ADDENDUM 1

Contract: 25-C-00011; Howard F. Curren Advanced Wastewater Treatment Plant TECO Building Modifications

GENERAL NOTES

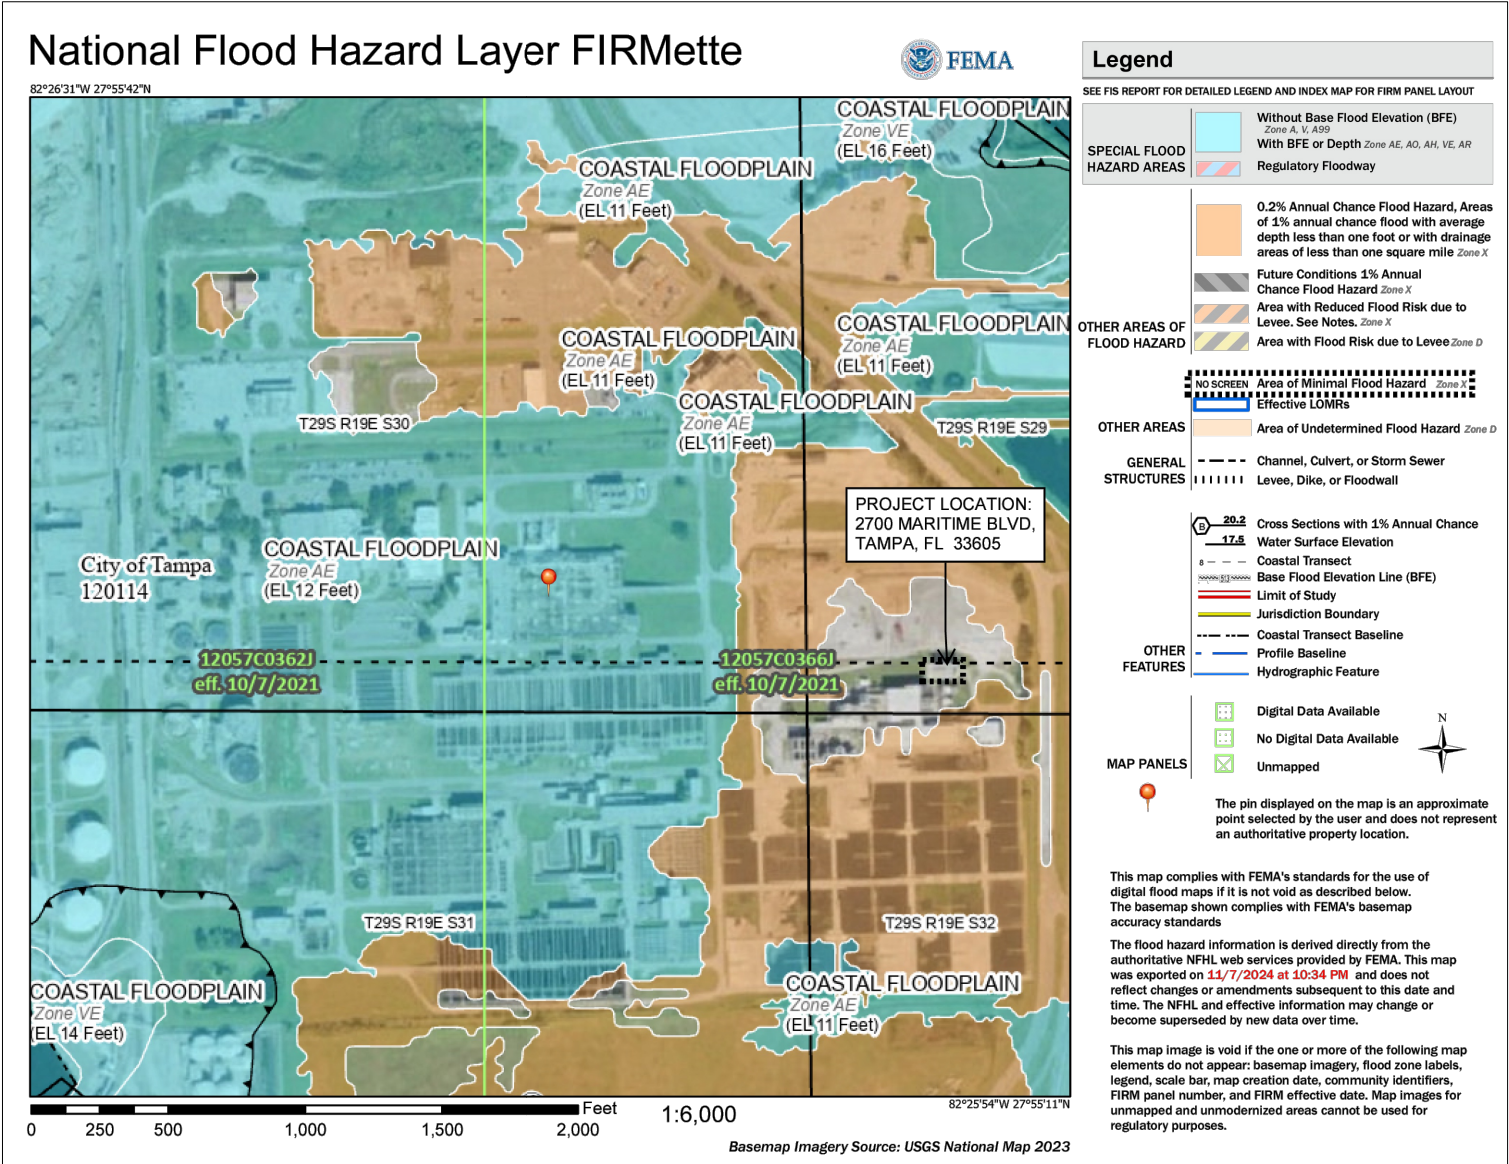
Item 2. Add the following Demolition Notes to the Drawings – Sheet 3

- B-5. THE CITY OF TAMPA DOES NOT BELIEVE ASBESTOS IS PRESENT IN THE STRUCTURE. PRIOR TO DEMOLITION, THE CONTRACTOR WILL BE REQUIRED TO PROCURE A THIRD-PARTY ASBESTOS SURVEY FROM A LICENSED ASBESTOS INSPECTION CONSULTANT. DEMOLITION CANNOT BEGIN UNTIL THE ASBESTOS SURVEY IS SUBMITTED TO THE ENGINEER. IF THE SURVEY DISCOVERS THE PRESENCE OF ASBESTOS, THE CITY WILL UTILIZE CONTINGENCY FUNDS FOR THE ASBESTOS REMOVAL BY A FLORIDA LICENSED ASBESTOS CONTRACTOR.
- B-6 THE CITY DOES NOT BELIEVE LEAD PAINT IS PRESENT IN THE BUILDING. THE CONTRACTOR WILL BE REQUIRED TO PROCURE A THIRD-PARTY LEAD PAINT INSPECTION CONSULTANT. DEMOLITION CANNOT BEGIN UNTIL THE LEAD PAINT SURVEY IS SUBMITTED TO THE ENGINEER. IF THE SURVEY DISCOVERS THE PRESENCE OF LEAD PAINT, THE CITY WILL UTILIZE CONTINGENCY FUNDS FOR THE LEAD PAINT REMOVAL.

Item 3. Add the following General Note to the Drawings – Sheet 3

A-10 A BUILDING PERMIT NUMBER, BLD-26-0523277, HAS BEEN ISSUED FOR THIS CONTRACT. ONCE THE CONTRACT HAS BEEN AWARDED, THE CONTRACTOR'S LICENSE SHOULD BE ADDED TO THE PERMIT.

3. Question: Please confirm that the specifications provided on sheet no.3 General notes A-6 & A-7 reflect the project requirements for the new fans and the emergency eye wash sink.

Response: Refer to W-66 Aluminum Supply Fans in the Contract Document for additional fan specifications.

Refer to Note A-7 on Sheet 3 for floor mount sink specifications.
